15E ATWS Performance Evaluation

The information in this appendix of the reference ABWR DCD, including all subsections, tables, and figures, is incorporated by reference with the following departures.

Figure 15E-1a ATWS Mitigation Logic (ARI, FMCARD Run-In, RPT, Manual Initiation)

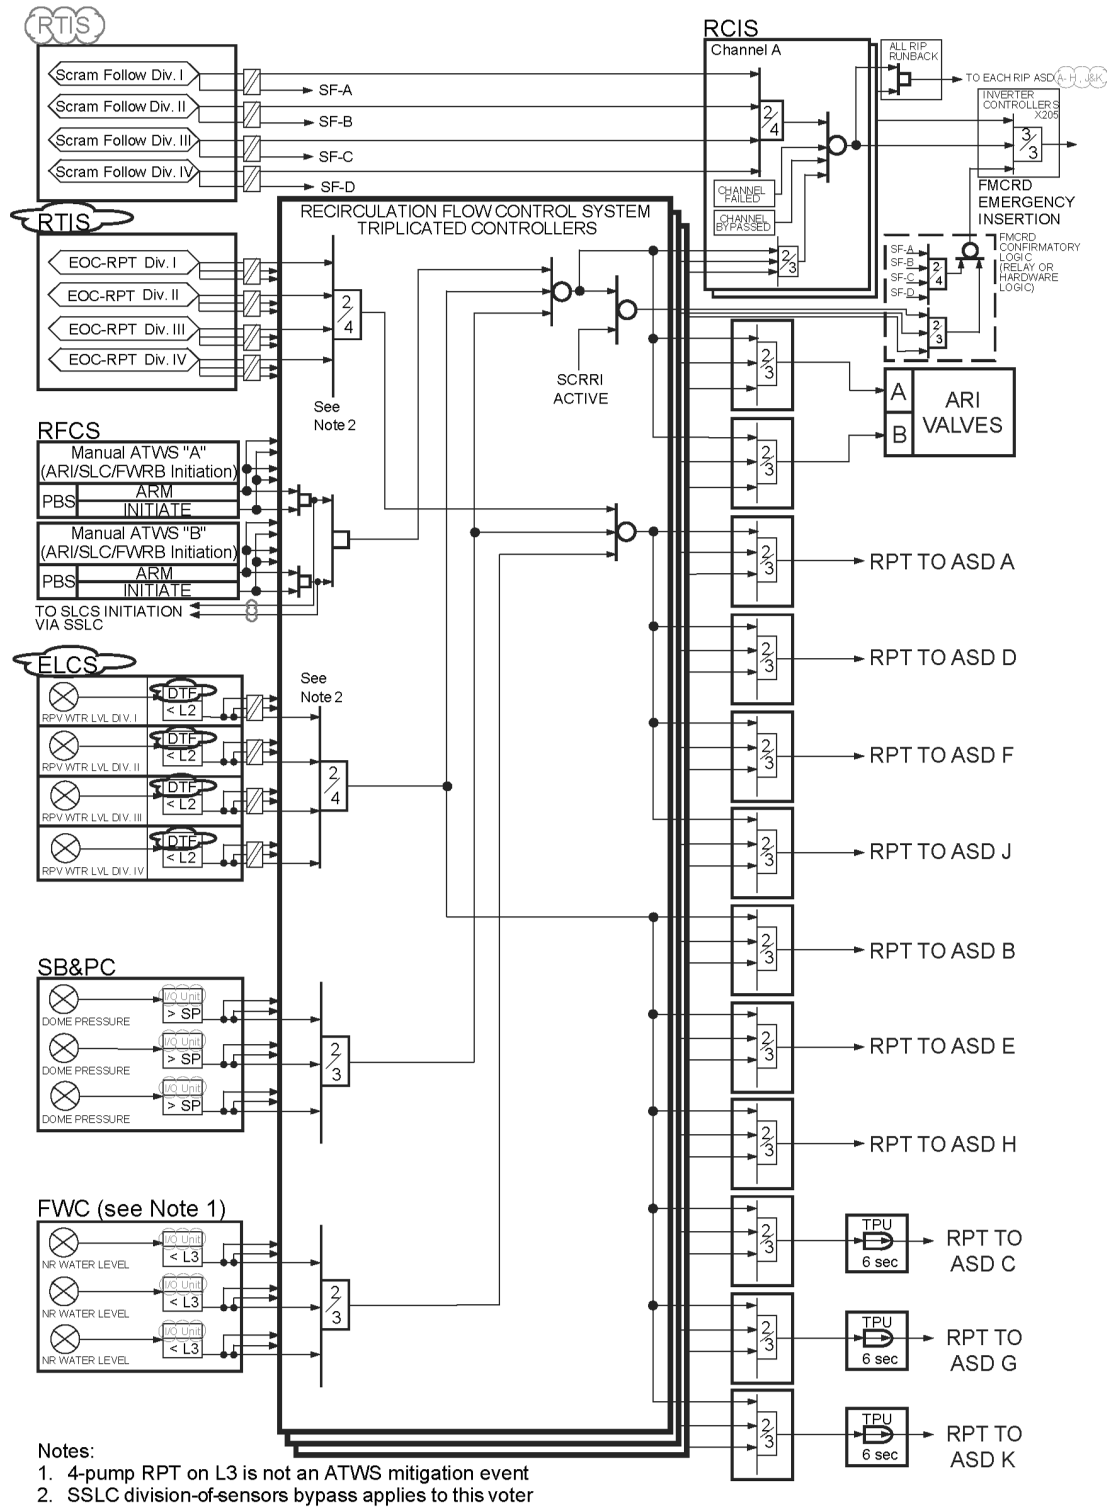
STD DEP T1 3.4-1 (Figures 15E-1a, 15E-1b, 15E-1c)

STD DEP Admin (Figure 15E-1a, Figure 15E-1b)

Figure 15E-1b ATWS Mitigation Logic (SLCS Initiation, Feedwater Runback)

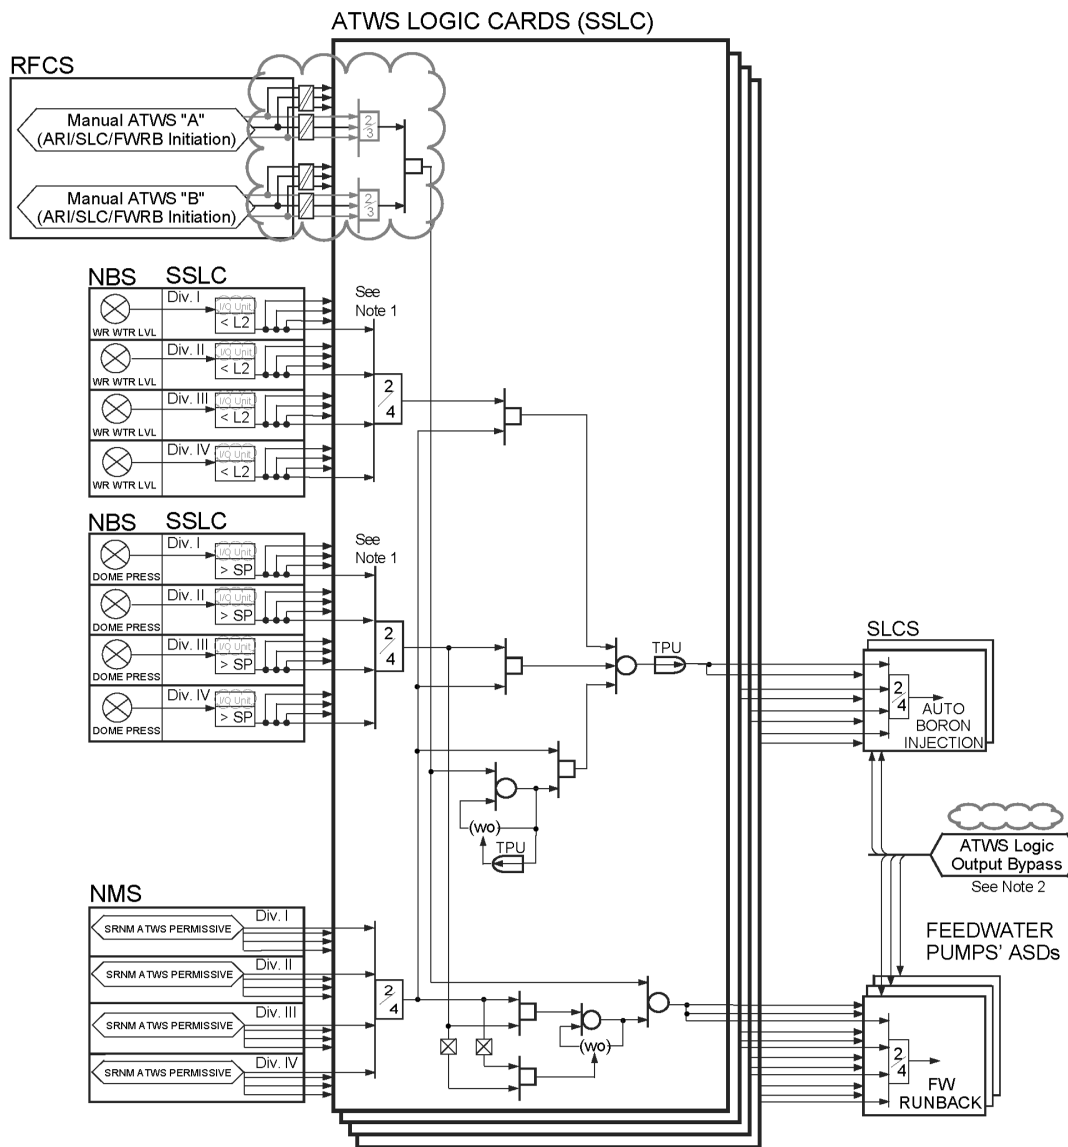
STD DEP 16.3-83 (Figure 15E-1b)
